SHOP DRAWING SUBMITTAL REVIEW FORM

PROJECT: York Region Administrative
Centre – Interior Fit-up
Package ‘D’

| Shop Drawing No.: | M-1 |
| Product: | Fan Coil Units |

~~For FCU 4.01 FCU 4.02, FCU 4.03 only~~

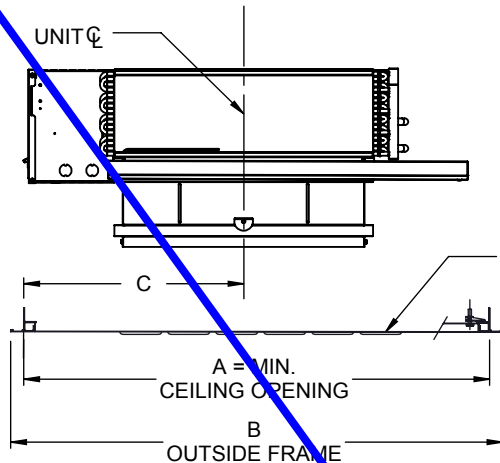
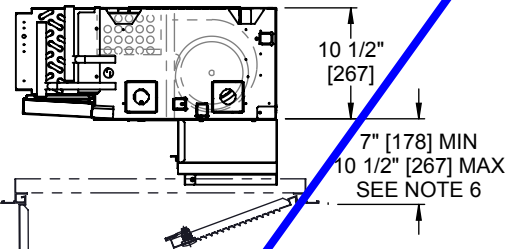
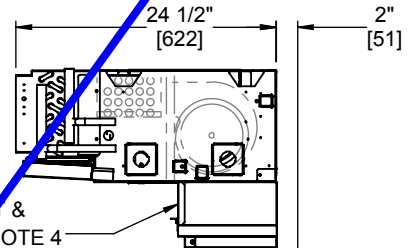
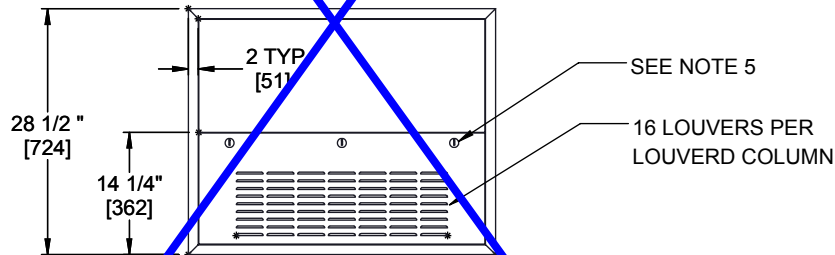
3. Fan coil FCU-4.38 model FHP-D03 has been added. (A CCN will be issued)
4. Fan coil FCU-4.02 & FCU-4.03 model shall be FHP-D06 with rear return & filter size of 31x10.5x1. Provide solid bottom ceiling access panel for drywall ceiling installation.

5. Fan coil FCU-4.01 model shall be FHP-D08 with rear return & filter size of 19x10.5x1. Provide solid bottom ceiling access panel for drywall ceiling installation.

47-80120-J

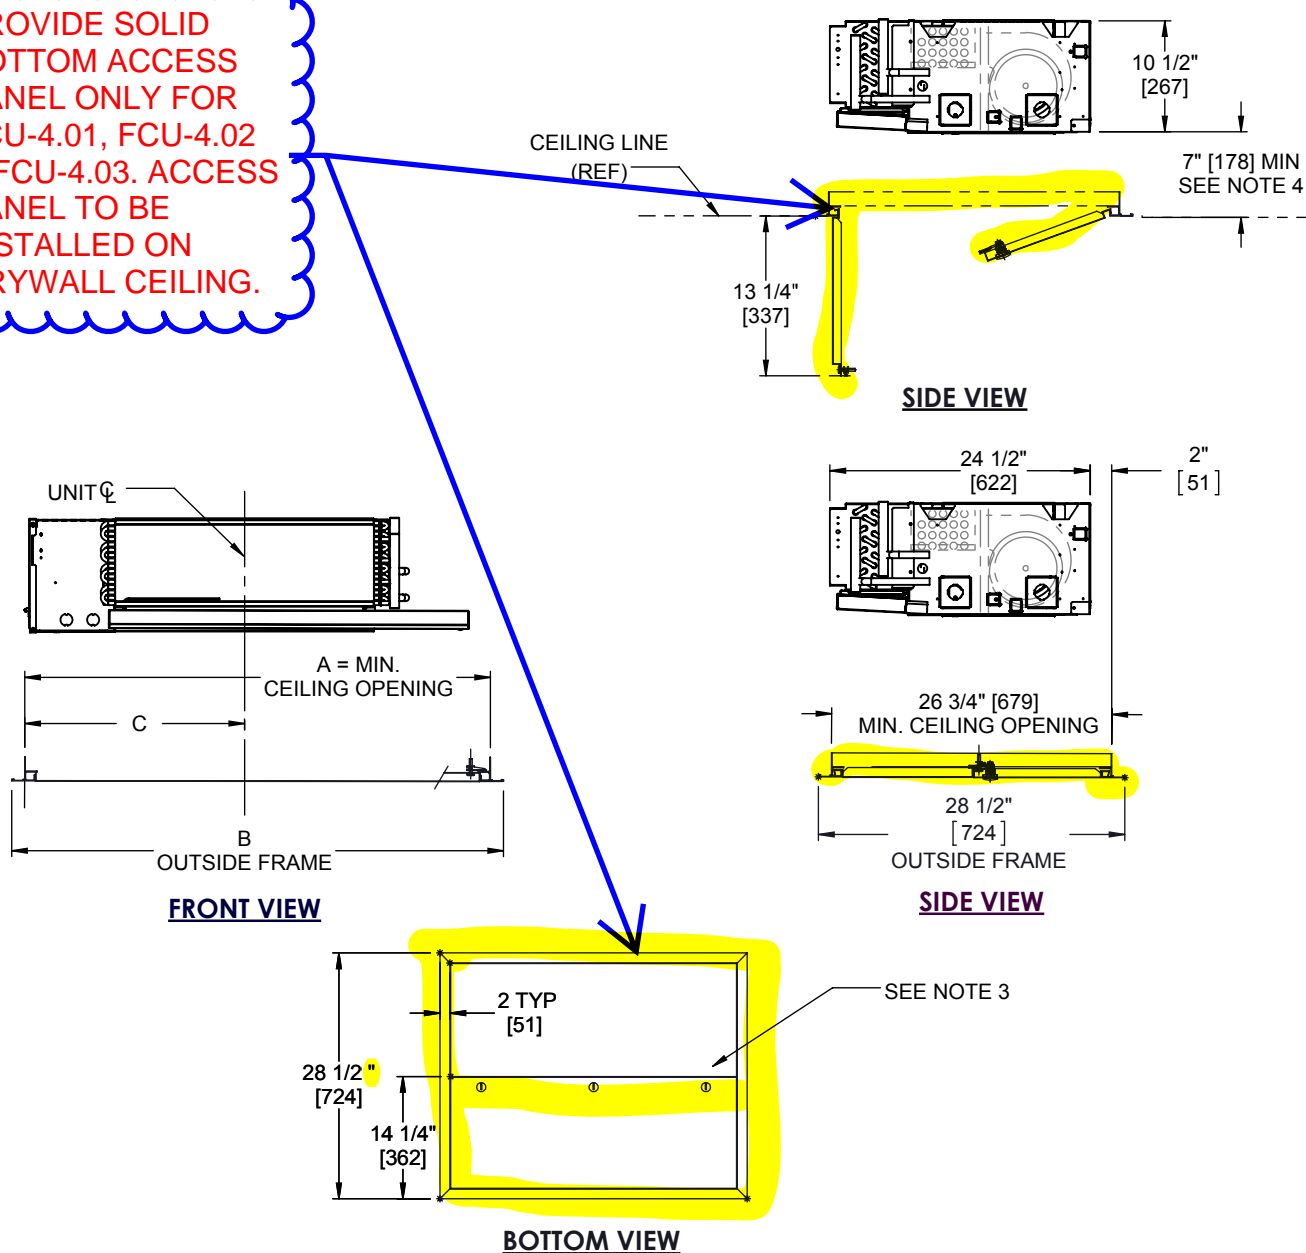
**PROVIDE SOLID
BOTTOM ACCESS
PANEL ONLY FOR
FCU-4.01, FCU-4.02
& FCU-4.03. ACCESS
PANEL TO BE
INSTALLED ON
DRYWALL CEILING.**
